SUBJECT: REQUEST FOR ADDITIONAL INFORMATION REGARDING CENPD-137,  
SUPPLEMENT 2-P

## REQUEST FOR ADDITIONAL INFORMATION CENPD-137, Supplement 2-P

**Subject:** Supplementary Information to FTI's Response to NRC's Request for Additional Information on BAW-10168, Volume II, Revision 2, October 1992; RSG LOCA - BWNT Loss-of-Coolant Accident Evaluation Model for Recirculating Steam Generator Plants.

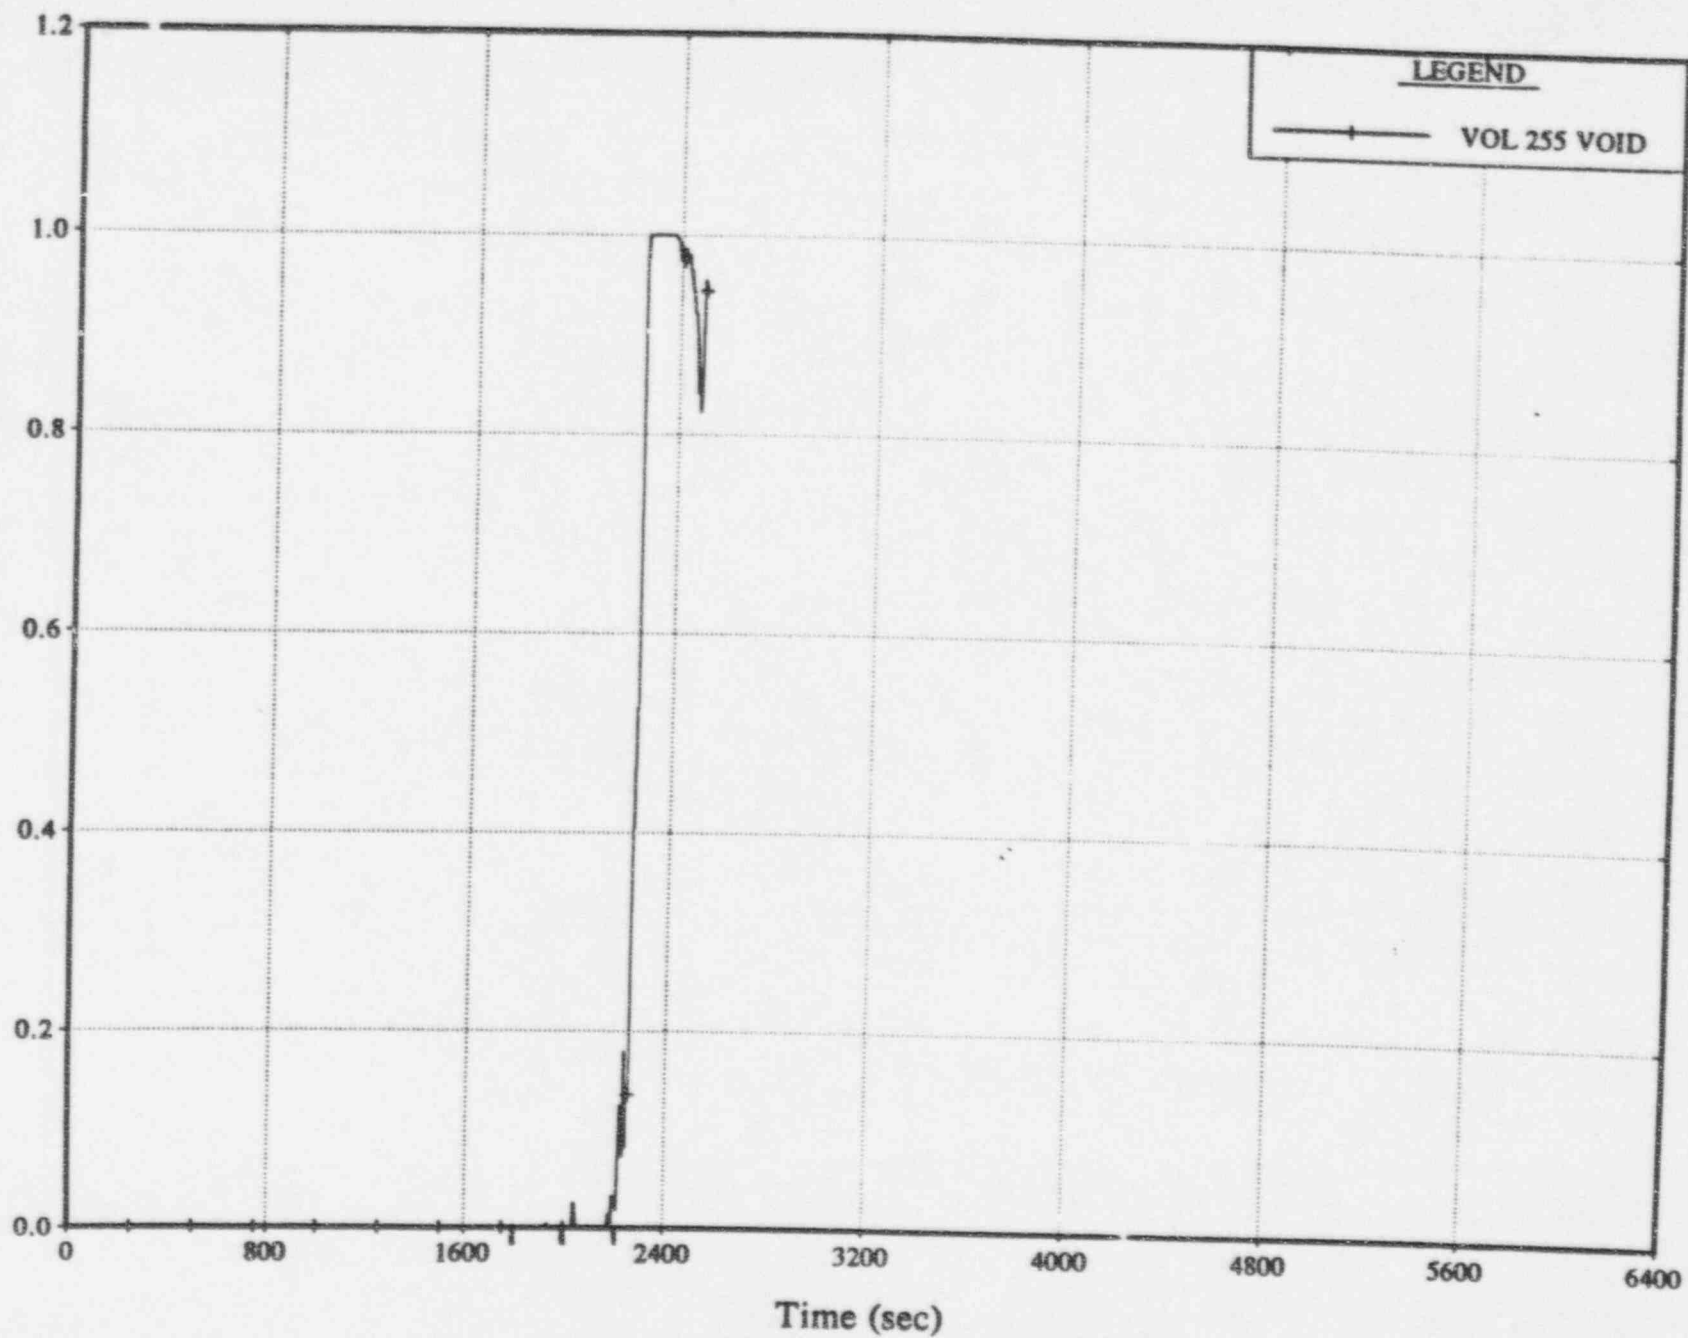
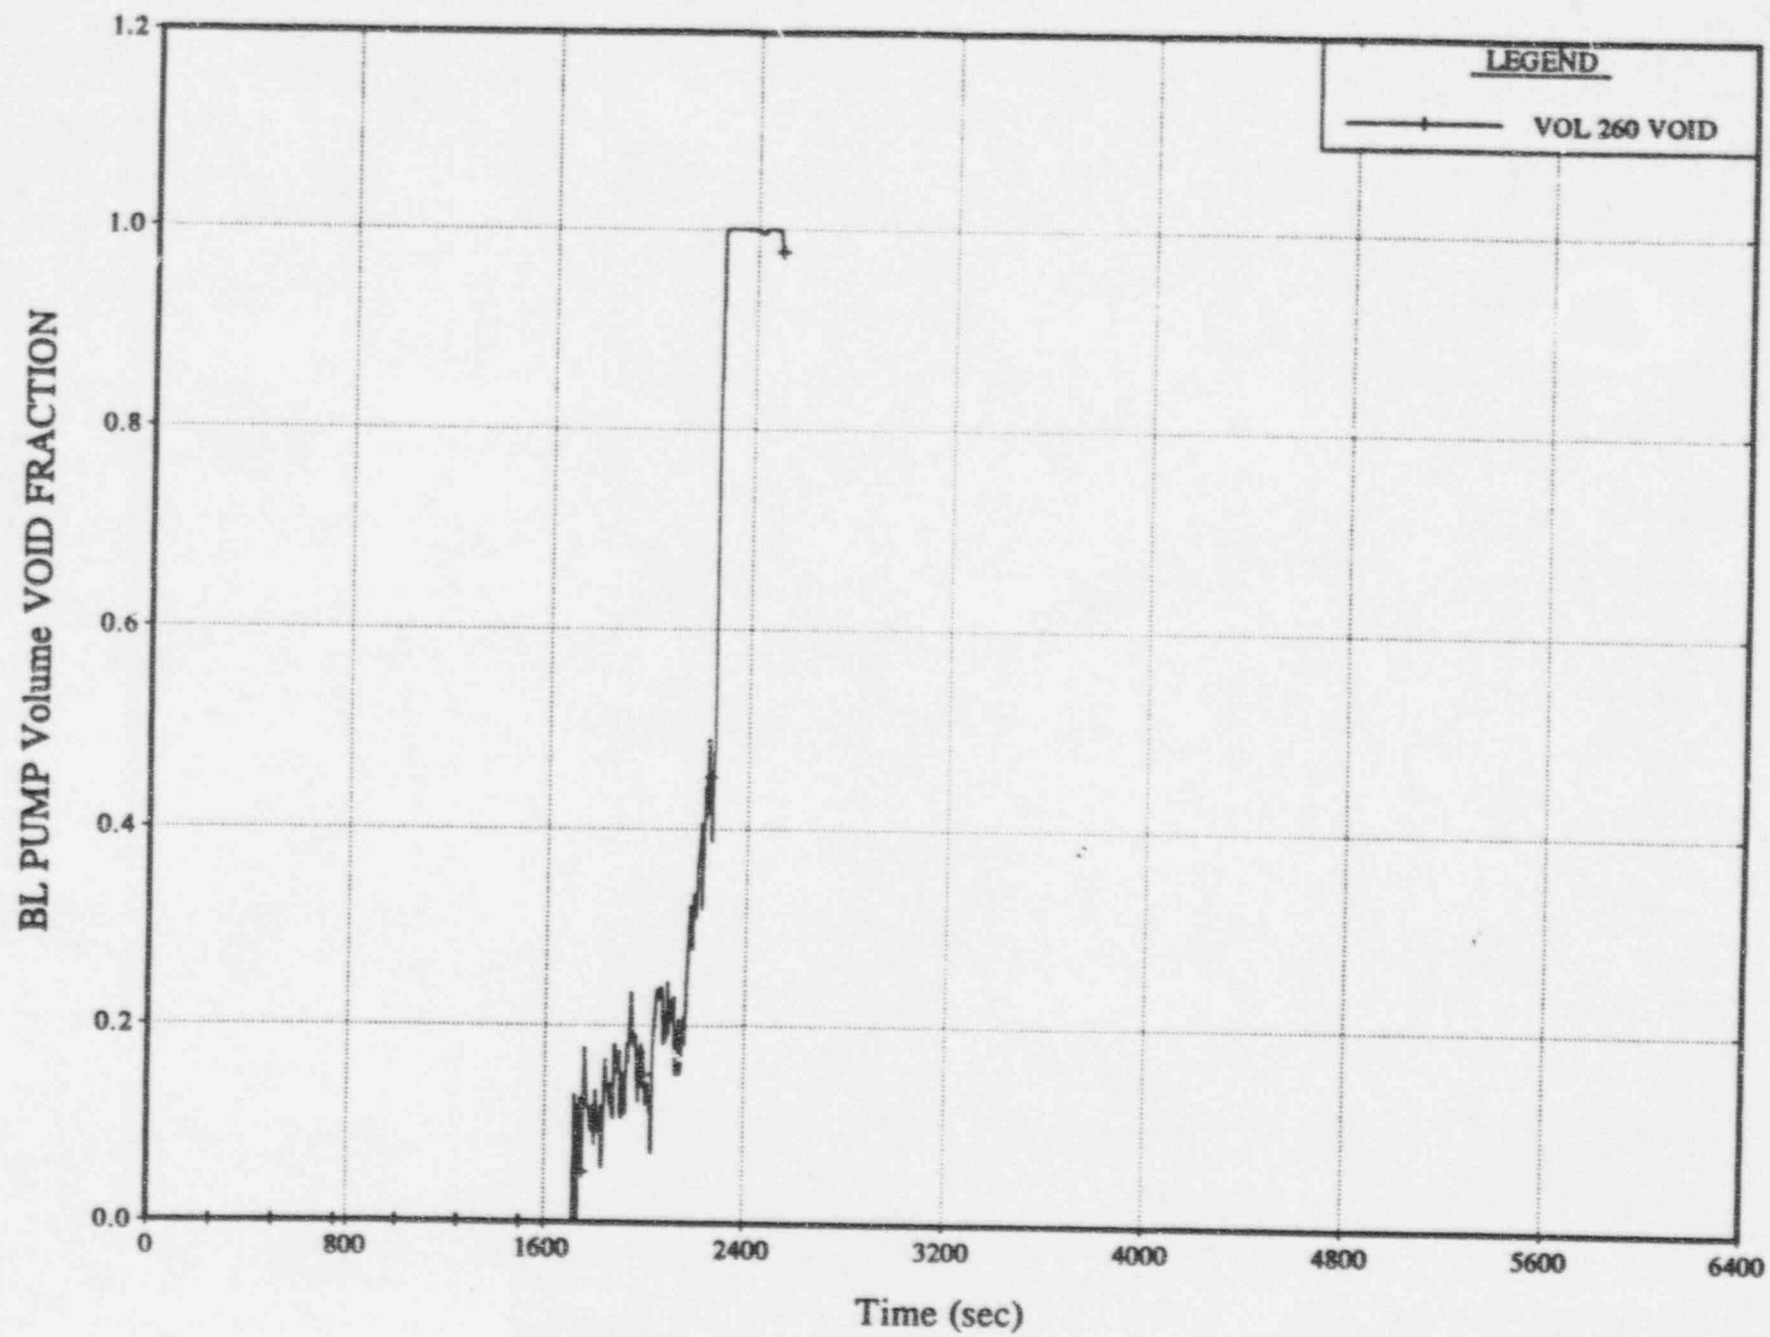
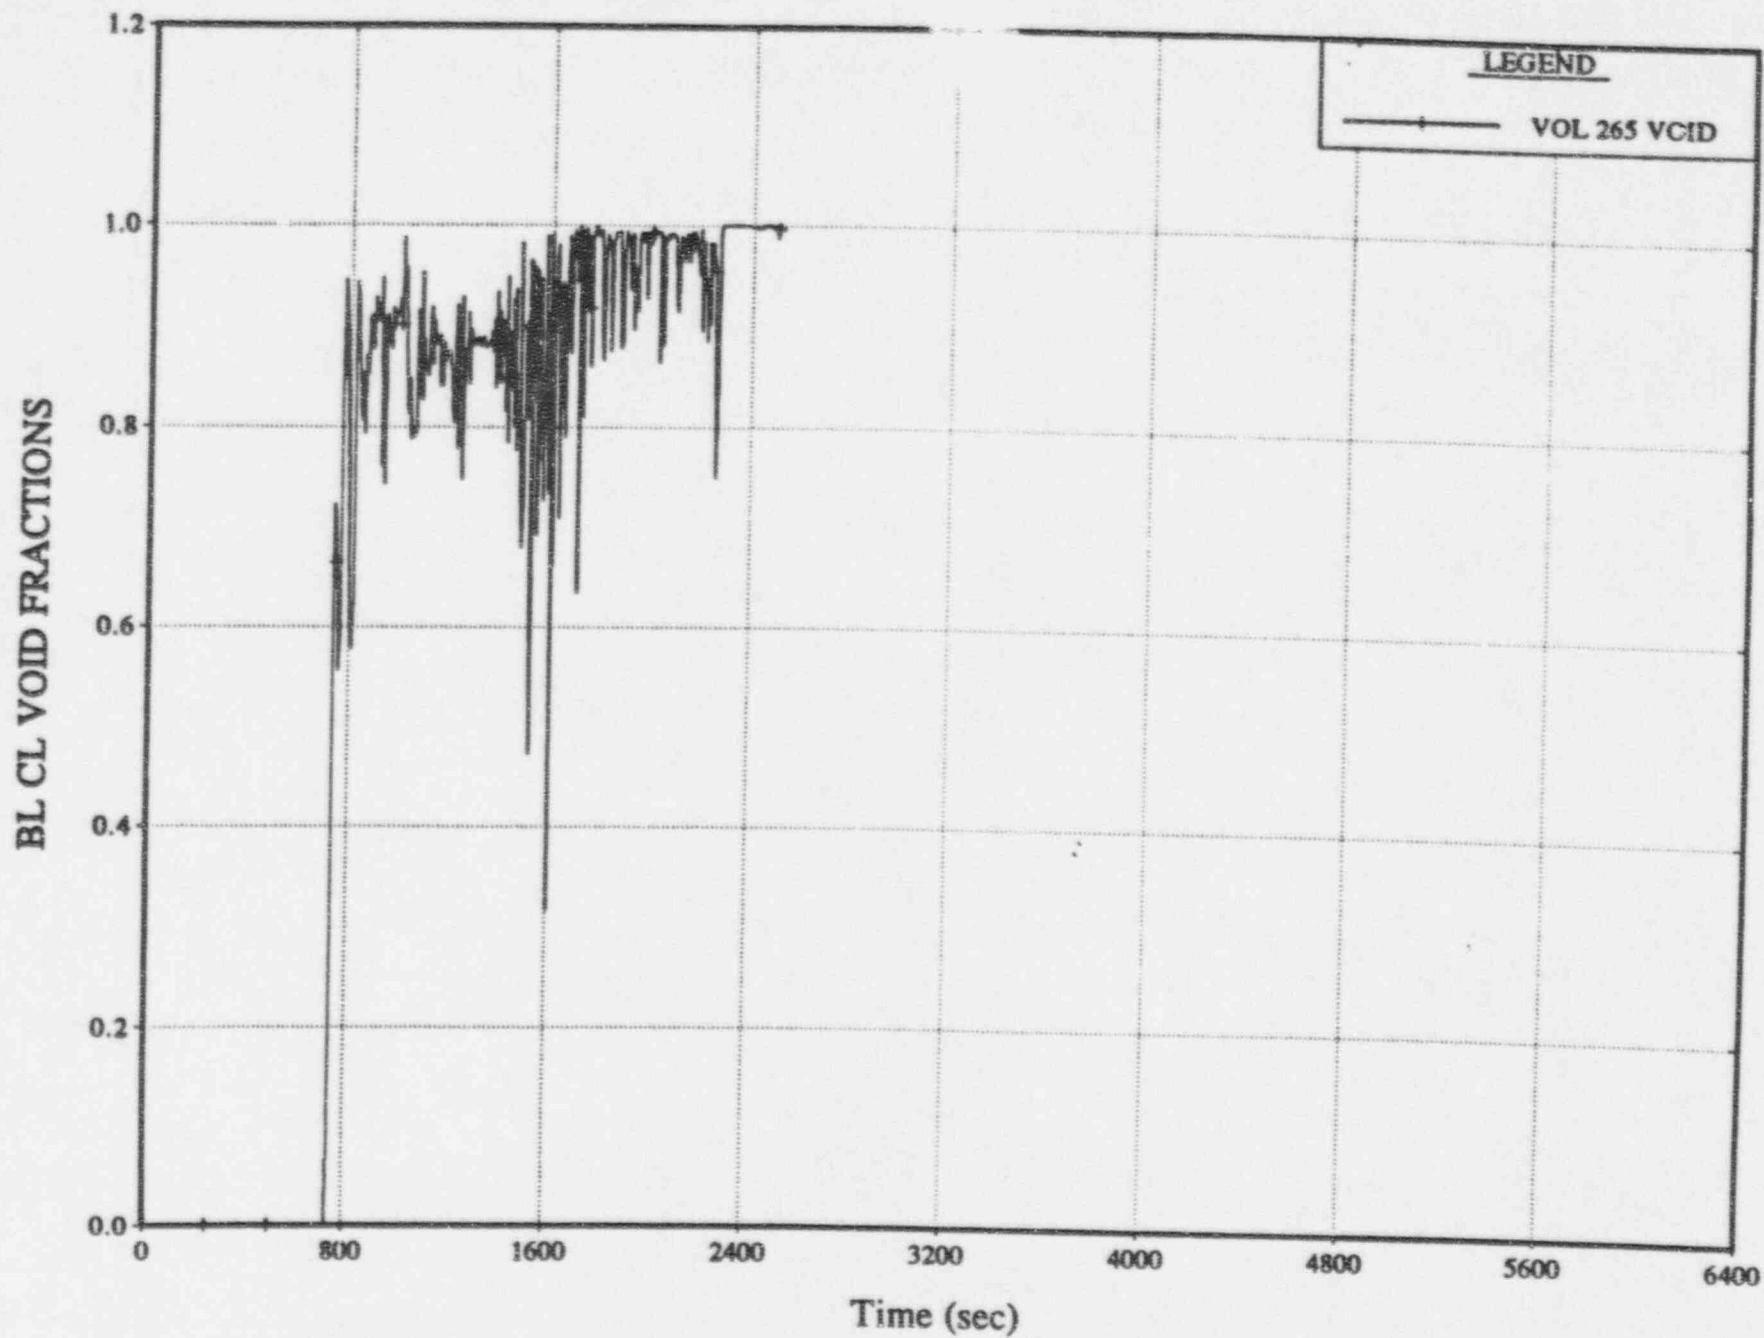
Figure 3 shows that the liquid level in the upside of the loop seal section starts to decrease after about 1700 seconds. The void fractions in Nodes 255, 260, and 265 are shown in Figures 6 through 8, respectively. From these figures it can be seen that the liquid level decrease in the loop seal upside section is caused by the increase in void fraction in the pump volume (Node 260). Steam venting from the loop seal occurs only after about 2200 seconds as shown in Figure 6. The pump discharge piping on the other hand is highly voided after about 750 seconds due to the steam flow from the upper head spray nozzles into the downcomer. At about 1600 seconds the break junction void fraction increases rapidly from zero to a highly voided state and the flow in the cold

Figure 10: Typical FTI SBLOCA 4-Loop RSG Pump Suction Noding Details

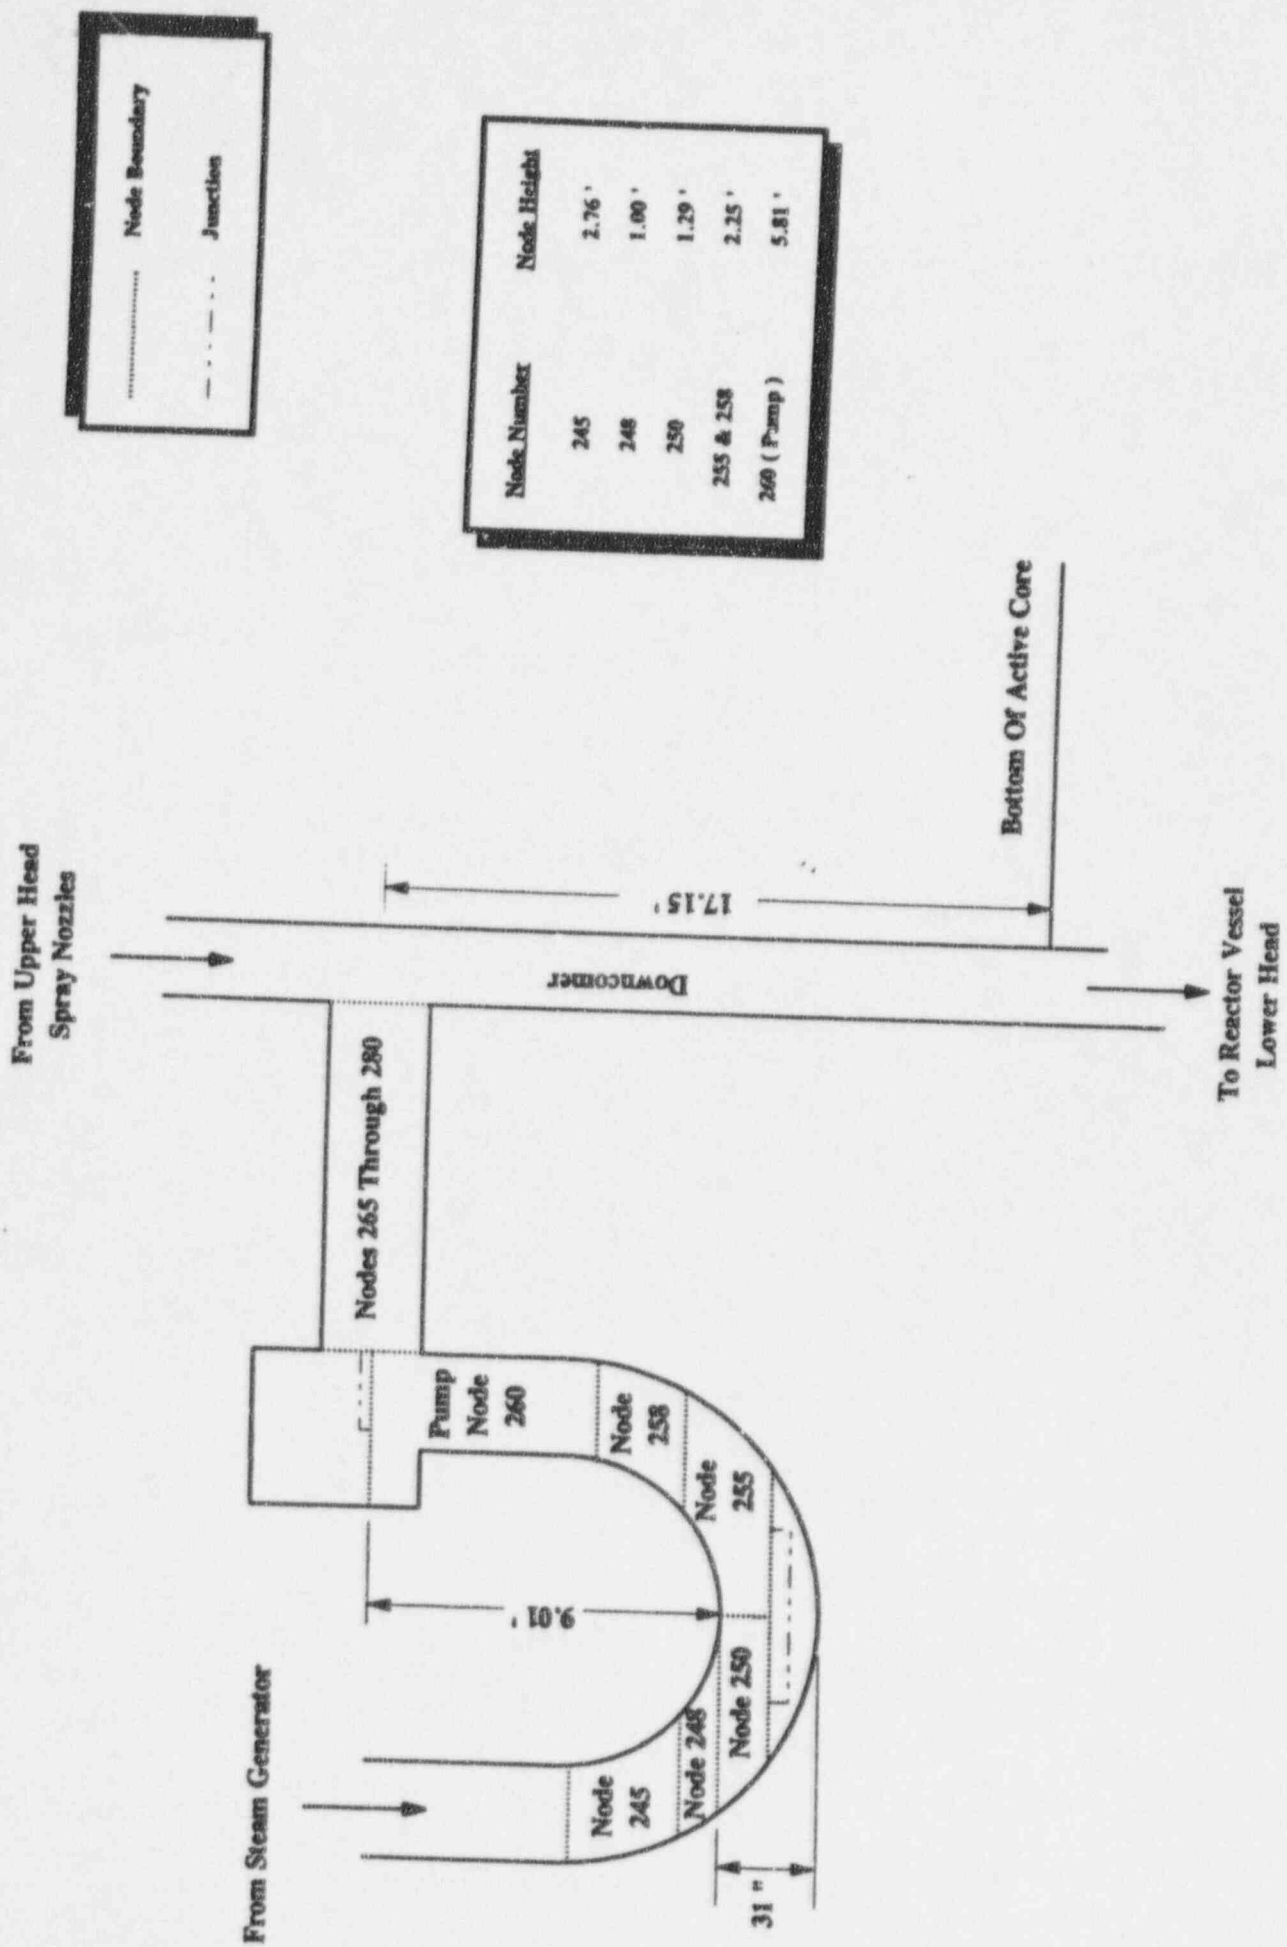
The broken loop pump suction noding for the base model is shown in Figure 10. To reduce early loop seal clearing, Node 248, representing the lower portion of the downside piping, was set at a small node height, 1 foot. The bottom of Node 248 coincides with the spill under elevation of the loop seal. Node 250 represents the horizontal portion of the U-bend and the height of this node is the radius of the pipe. Node 260 represents the pump. The height of Node 260 is 5.81 ft which is the actual height of the pump up to the centerline of the discharge piping. In RELAP5, the pump volume also uses the high mixing flow regime, and, therefore, slug flow (Wilson drag) is not used in this node, even though it is a vertical node.
